Access Compliance Report

Public Rights-of-Way

Intersection ID: 10036062	Main Street: RIVERGATE_PY	Cross Street: N/A	Location: SW
ADA ID: 92DA6F087ABC	Ramp Type: BlendTrans2	Initial Pass/Fail: Fail	Overall Compliance: No
Severity Score: 1.25			
Codes/Mitigation Info/Possible Solution		Field Measurements/Component Compliance

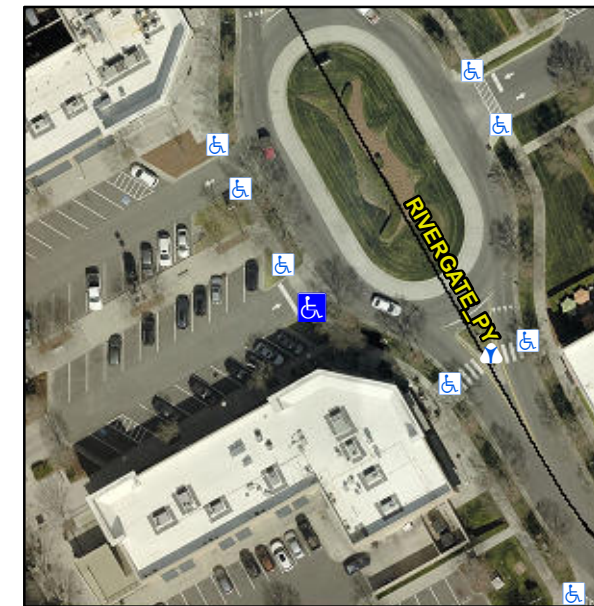
Compliance	Description	Data	Compliance	Description	Data
N/A	Ramp Length (in)	61.5	Yes	BlendTrans Slope (%)	3.5
Yes	Ramp Width (in)	72.0	No	BlendTrans XSlope (%)	4.1
N/A	Flare Type LT	N/A	N/A	Flare Type RT	N/A
N/A	Flare Slope LT (%)	N/A	N/A	Flare Slope RT (%)	N/A
N/A	Flare Traversable LT?	N/A	N/A	Flare Traversable RT?	N/A
N/A	Landing Length (in)	N/A	N/A	DWS Provided?	N/A
N/A	Landing Width (in)	N/A	N/A	DWS Contrast?	N/A
N/A	Landing Slope (%)	N/A	N/A	DWS Length (in)	N/A
N/A	Landing X Slope (%)	N/A	N/A	DWS Full Width?	N/A
N/A	Landing Curb? (Y/N)	N/A	N/A	DWS Offset (in)	N/A
N/A	Shared Landing?	N/A			
N/A	Gutter Ponding?	N/A	N/A	Gutter Slope (%)	N/A
N/A	Gutter Lip Ht (in)	N/A	N/A	Gutter X Slope (%)	N/A
N/A	Painted X Walk1?	No	N/A	Painted X Walk2?	N/A
	X Walk 1 Direction	To NW		X Walk 2 Direction	N/A
	X Walk 1 Width (in)	N/A		X Walk 2 Width (in)	N/A
	X Walk 1 Slope (%)	1.5		X Walk 2 Slope (%)	N/A
	X Walk 1 X Slope (%)	1.1		X Walk 2 X Slope (%)	N/A

Remove & Replace Curb Ramp With Two New Directional Ramps or Equivalent.
